MEMORANDUM

SUBJECT: Site Plan Approval – 1068 Arsenal Street

DATE: August 28, 2025

Please accept this letter as our response to the NYSDOT review comments dated 08.18.2025 for the approval of civil construction documents for a 7—Brew drive-thru coffee kiosk. For your convenience, comments have been provided in italics and our response in blue. Construction drawings have been revised and noted as Revision 4, dated 08.22.2025, with the incorporated changes to the corresponding comments below.

TRAFFIC CONTROL
PLAN

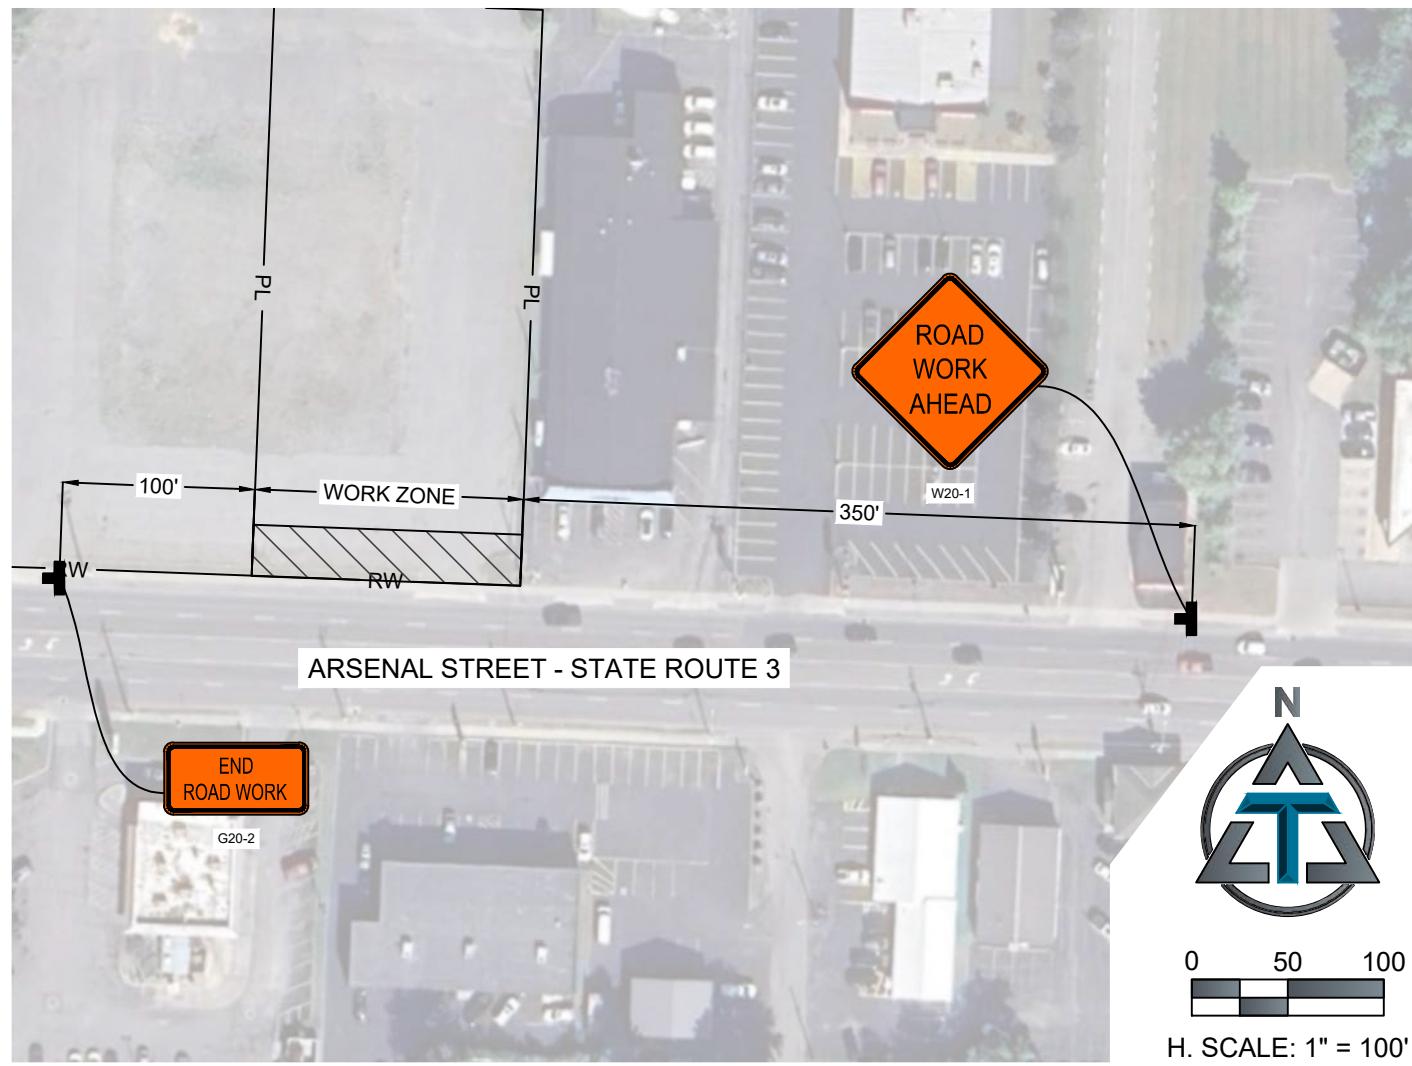
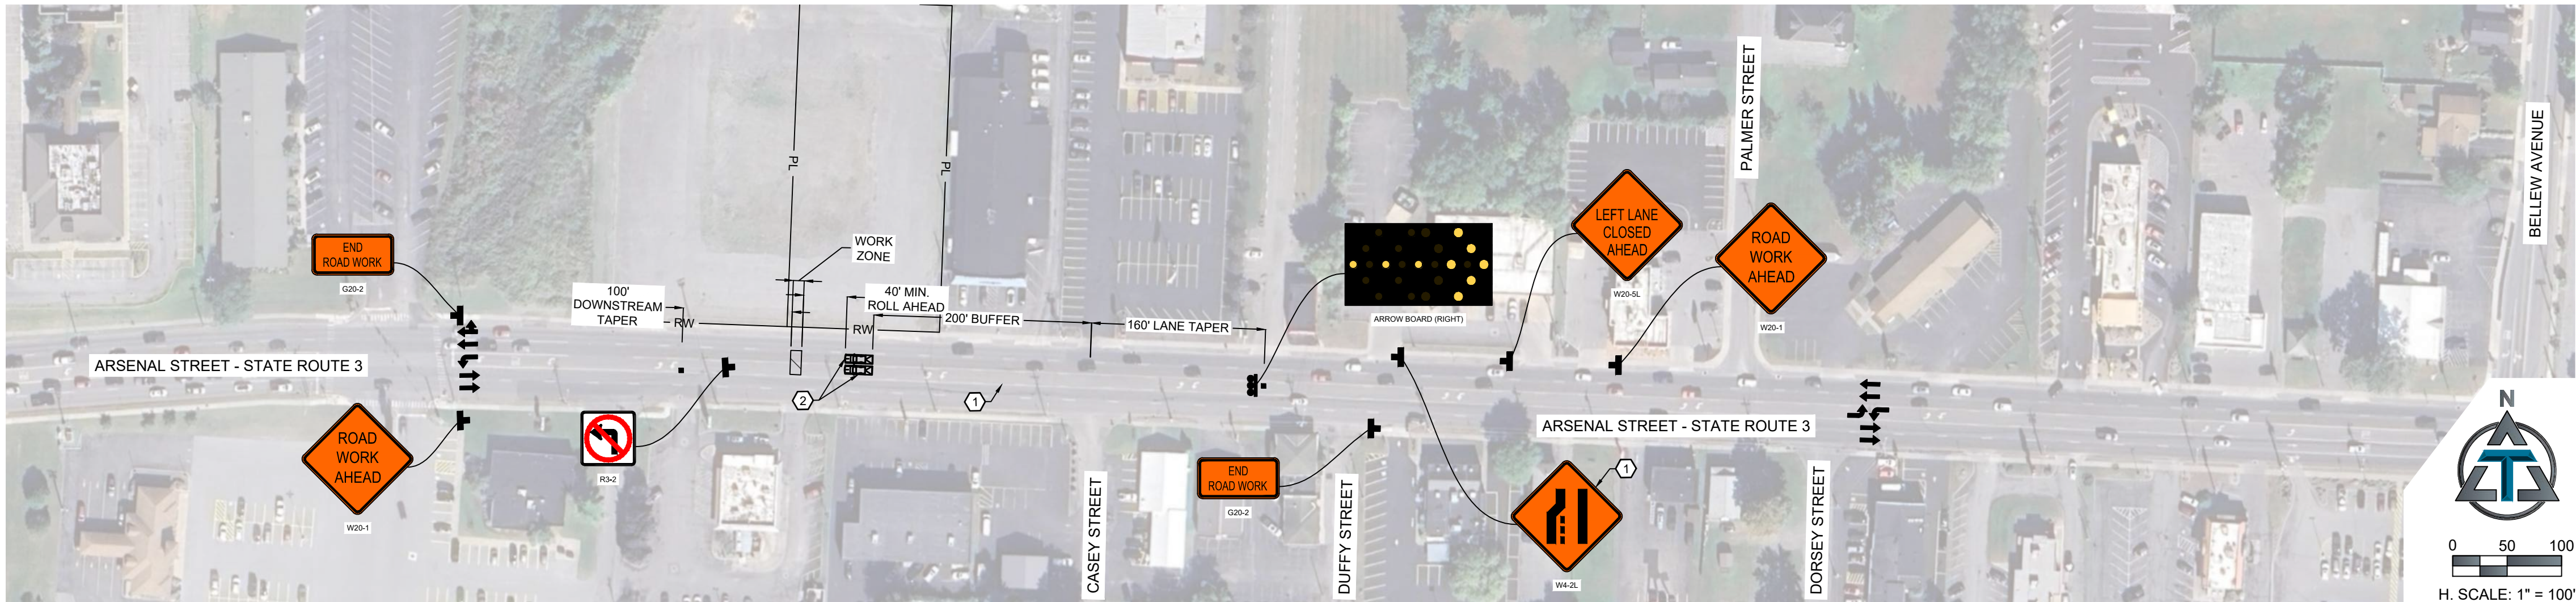
Response: A pedestrian detour has been added, see revised C1.3 – Traffic Control Plan.
13. Change Region 7 Notes on Sheet C1.3 to the attached.
Response: Region 7 Notes have been updated, see revised C1.3 – Traffic Control Plan.

C2.1
SITE PLAN

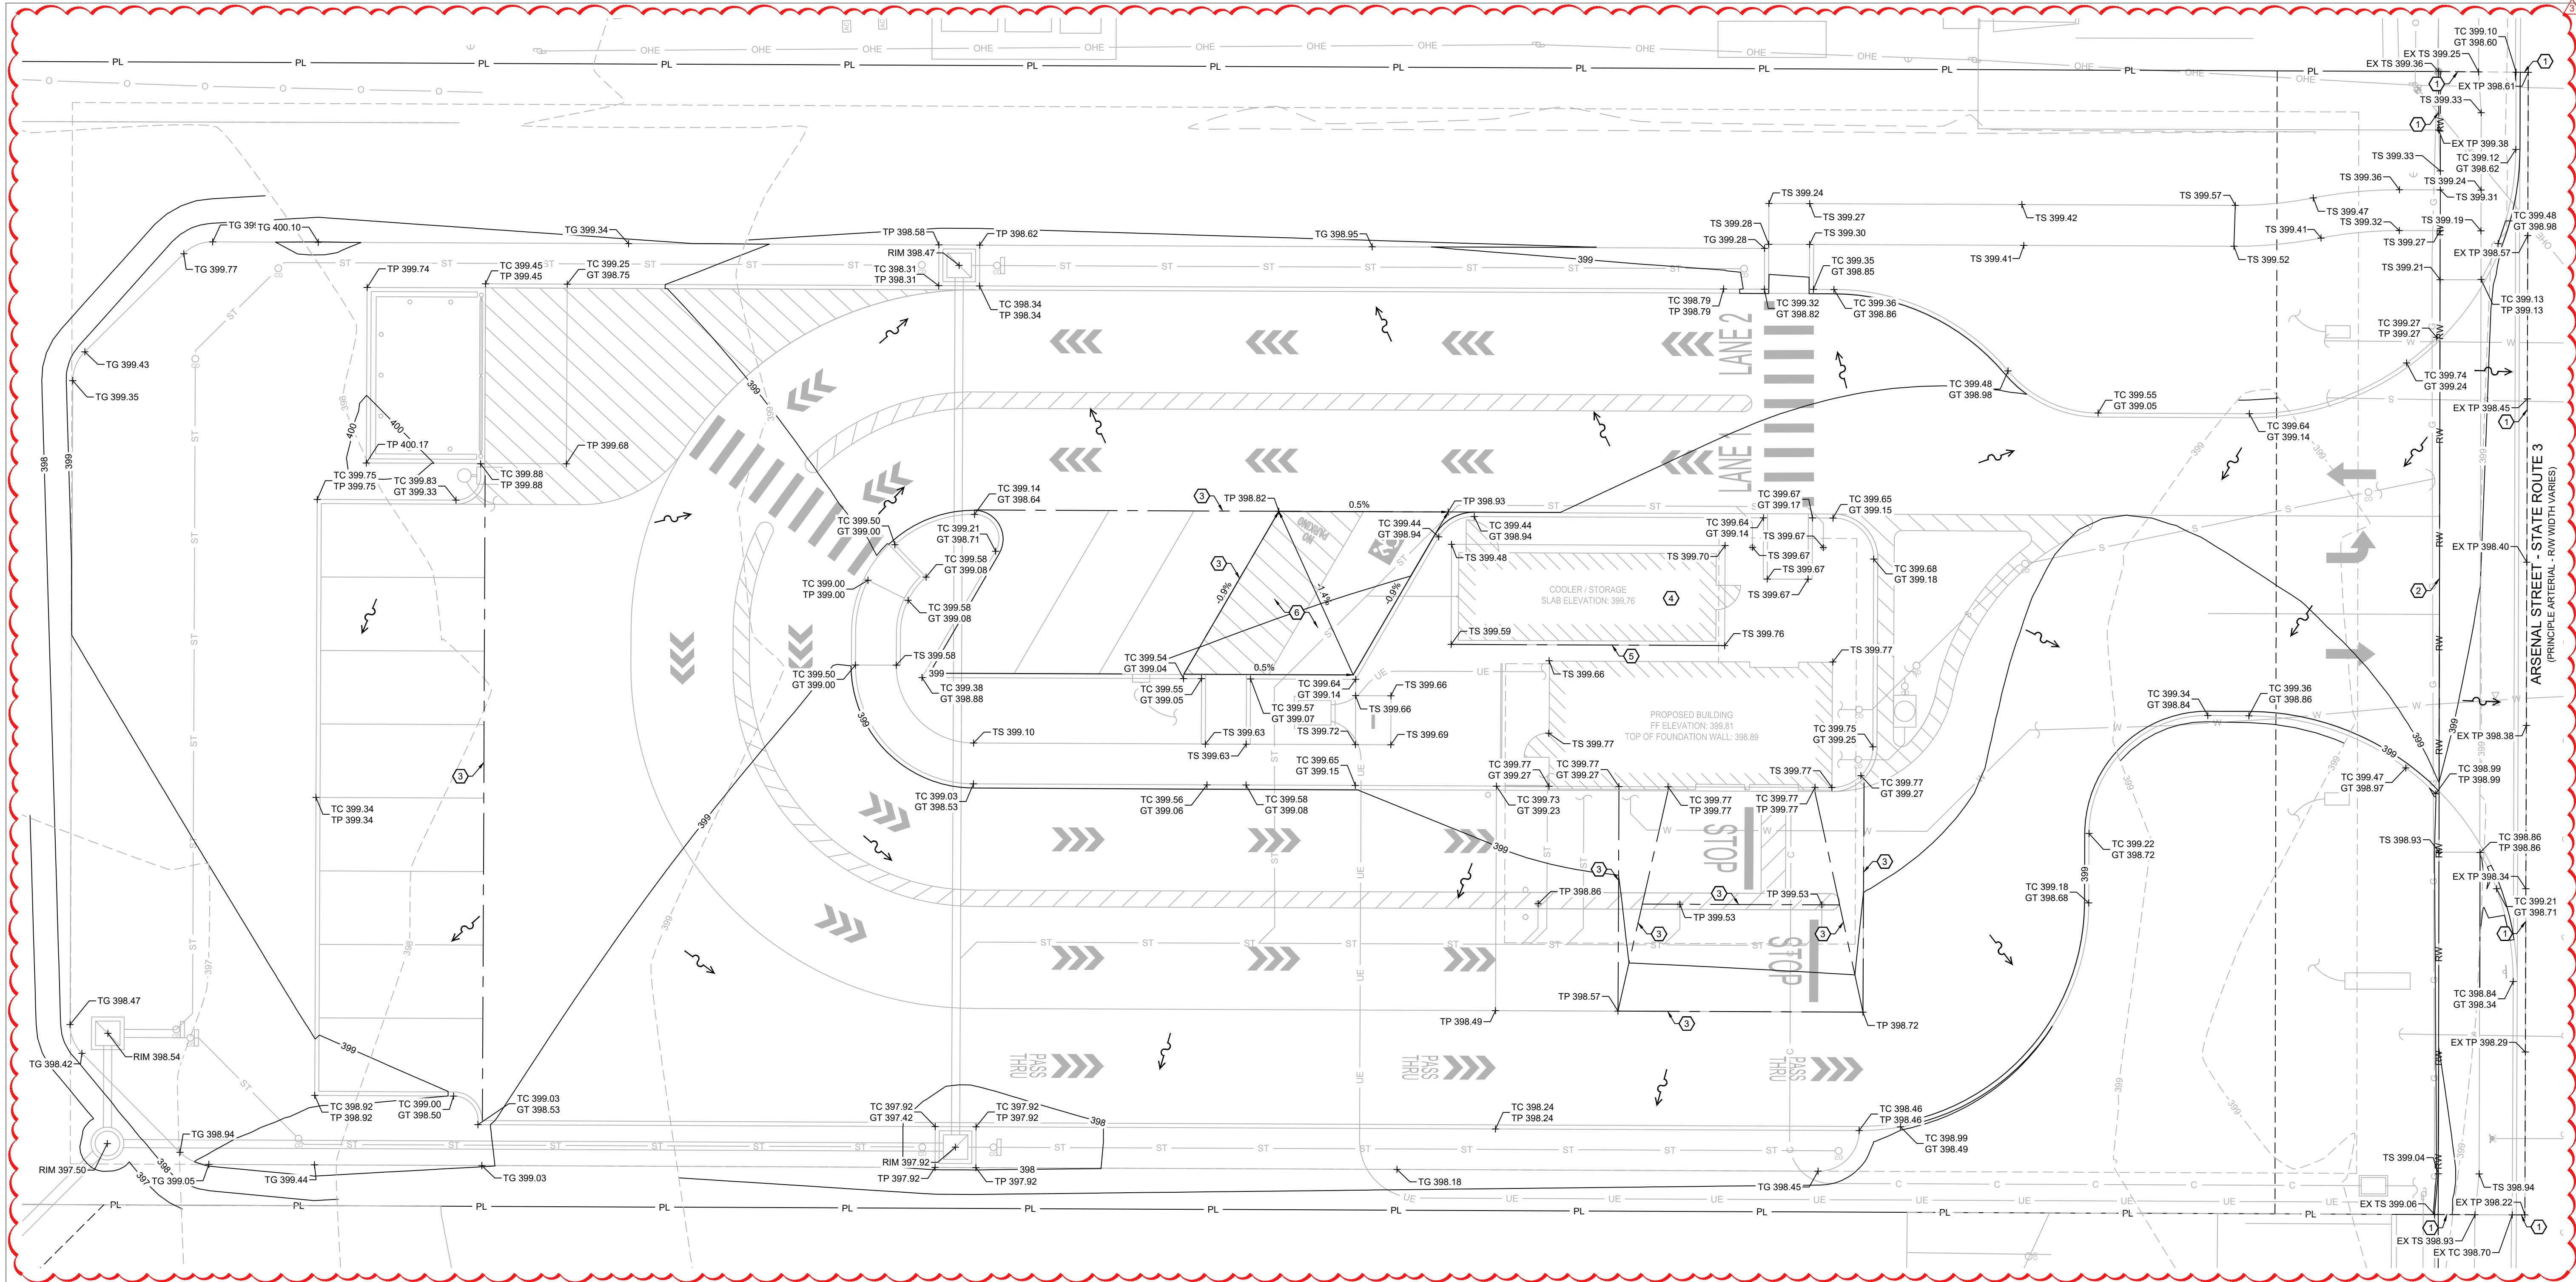
1. Design the driveway entrance utilizing the Taper Method, not the Radius Method..
Response: The proposed driveway entrance has been revised to utilize the Taper Method, see revised C2.1 – Site Plan.

2. The driveway design shall only have one entrance and one exit lane.
Response: The proposed driveway entrance has been revised to provide one entrance lane and one exit lane, see revised C2.1 – Site Plan.

3. Provide a dimension from proposed driveway to adjacent driveways.
Response: A dimension has been added from the proposed driveway entrance to the adjacent driveway, see revised C2.1 – Site Plan.

Response: A fire hydrant is required to be located on the project side of the street.
6. Show the easement needed from adjacent property owner for drainage outlet pipe.

Response: Driveway spacing has been confirmed to measure 75 feet from edge of driveway to edge of driveway, see revised C2.1 – Site Plan.
5. What is the reasoning behind the 6" water main crossing and pavement cut in Arsenal St?..

Response: A keynote has been added to define a proposed 10-foot storm drain easement for the stormwater pipe, see revised C2.1 – Site Plan.
7. Provide a drainage study following the template in Chapter 8 of Highway Design Manual for the drainage that outlets into the NYSDOT drainage ditch.

C3.1
GRADING PLAN

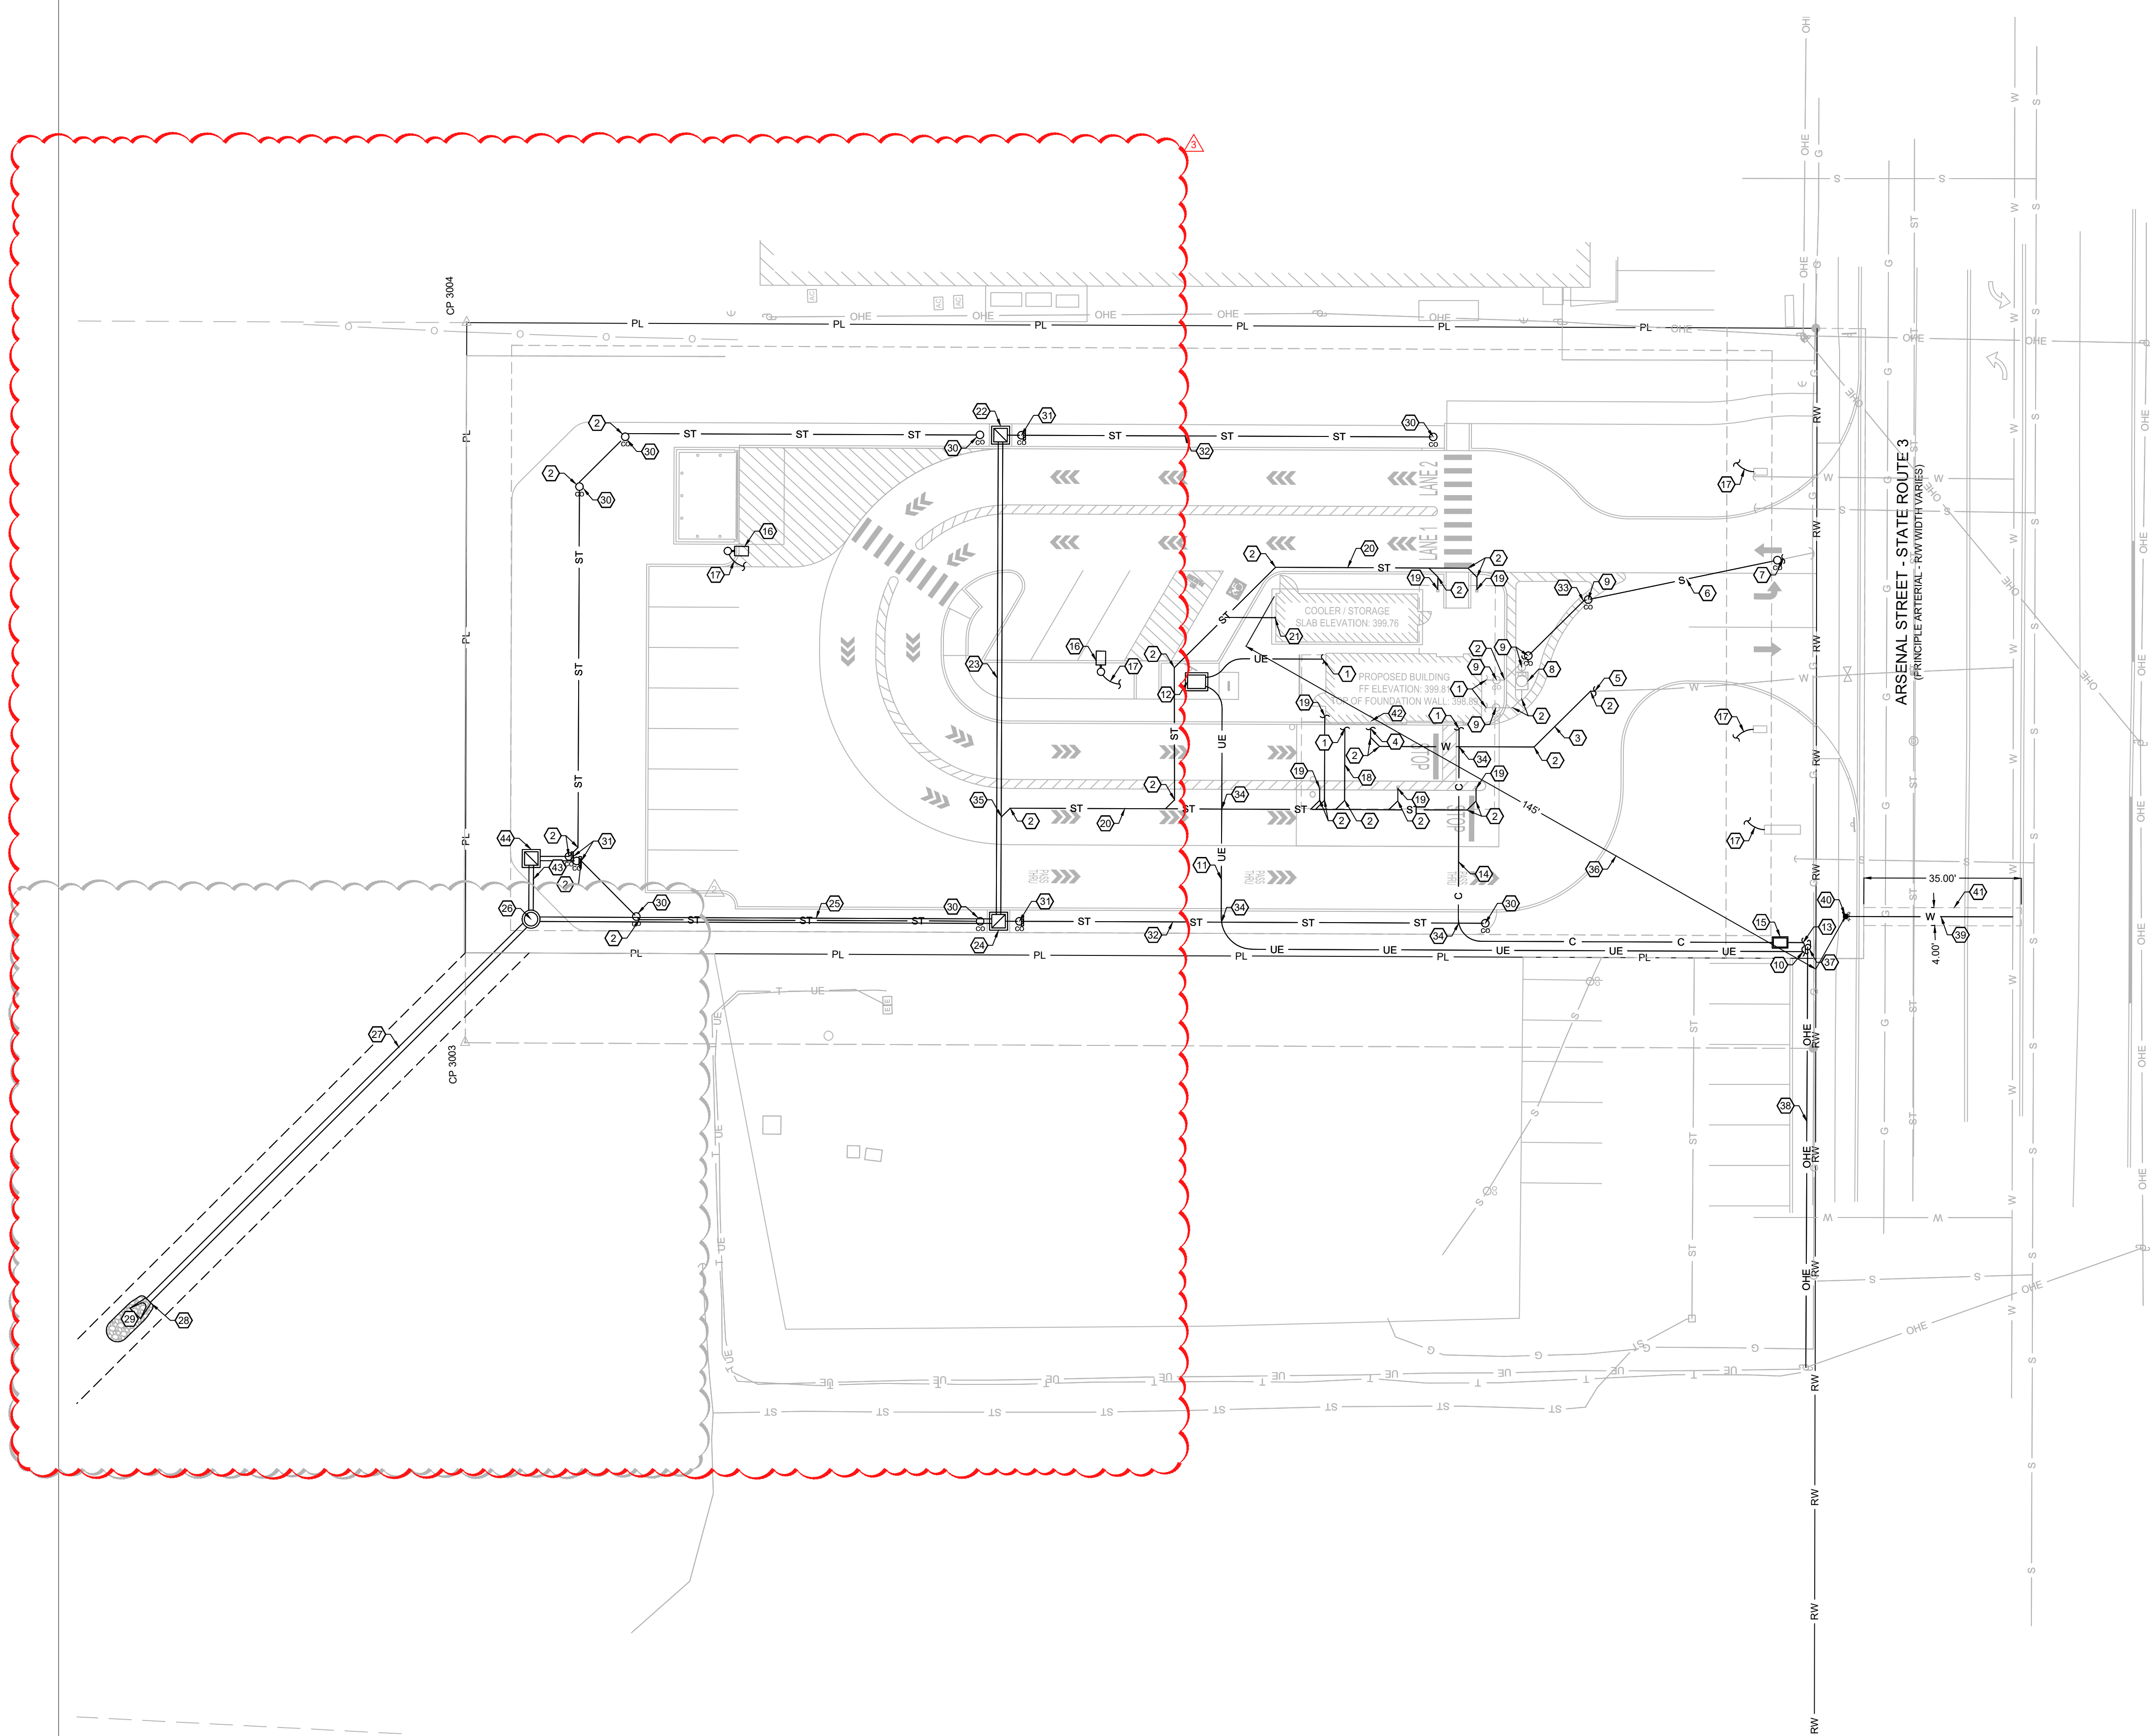
Response: The proposed driveway has been designed with this consideration.
10. Label transition locations and slopes according to ADA requirements.
Response: Spot elevations have been added to define ADA transitions and slopes, see revised C3.1 – Grading Plan.
